Product/Process Change Notice

Application or type : Schottky Bridge Rectifier TO-269AA SMD (MDS) structural framework change.

堆疊式(舊框架)

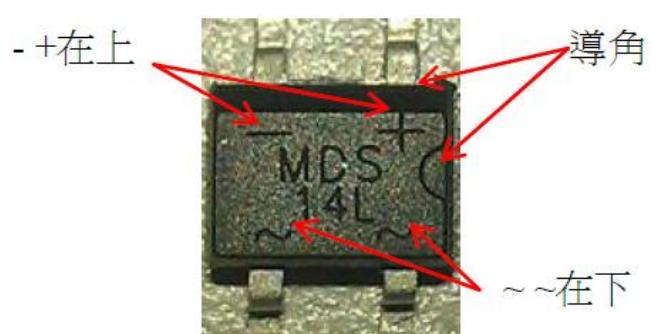
Detail of the change : Structural framework change.

Current :
